This paper lists the known errata for the Local Bus Specification Revision 2.2. If you have found others please mail them to techsupp@pcsig.com.

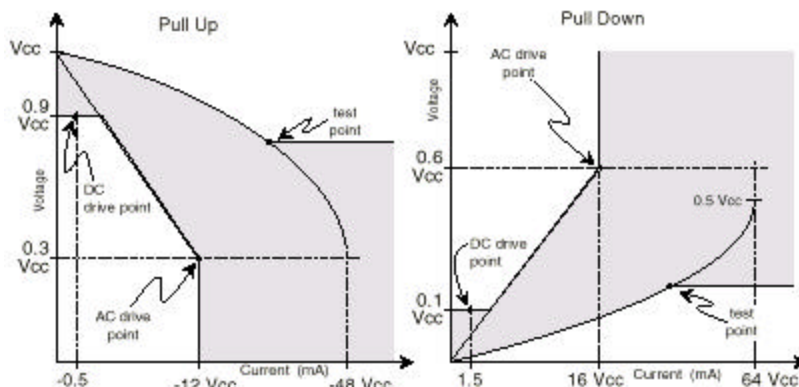
4. In section 7.6.4.1 there is a value in Table 7-3 that is incorrect. The maximum value for f_{spread} (frequency spread) should be 0%, not 9%.
5. The diagrams in Figure 4-4 are missing some text on the X-axis. The figures below (the same as appeared in the Rev. 2.1 specification) are correct. Along the X-axis, values including V_{cc} mean the number times V_{cc} expressed in milliamps. So the first value (-12 V_{cc}) means -12 times V_{cc} or -39.6mA (-12 * 3.3).
